Technical Queries

The following is a selection of questions submitted to the Members' Advisory Panel, together with the replies which were forwarded to the enquirers. All of the queries relate to section F of the SMM. We would be interested to receive the comments of readers who may be able to amplify any of the replies or who may have different views to offer in respect of them.

SECTION

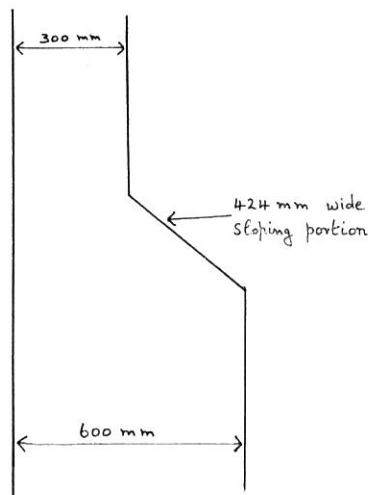
Formwork to Sloping Surface

A problem has arisen regarding certain clauses in the Standard Method of Measurement regarding formwork to battering walls and ditto to upper sloping surfaces.

Would you please inform me at what angle formwork to battering walls becomes formwork to upper sloping surface as this is not stated in the Method.

The problem has occurred on a retaining wall around the site where a 424mm sloping portion occurs approximately half way up the wall (see diagram below). The angle of this sloping portion is approximately 45° from the horizontal.

Would you please inform me of your opinion regarding measurement of the above.

Clause F 20 (a) states "Formwork shall be measured . . . including the upper surfaces of the work sloping more than 15° from the horizontal." This figure is also quoted in F21 (a) (iii) and (xi) and it is reasonable to assume that this is the point at which formwork to upper surfaces becomes measurable.

The SMM is not definitive on at what point a section of battering wall becomes an area of upper sloping surface. It is a matter for individual interpretation. However, in this case the Panel is unanimous in considering that the sloping area of the wall should be measured as "formwork to upper sloping surface", though opinions varied as to whether this should be under F20 (a) or F21 (a) (iii) or (xi).
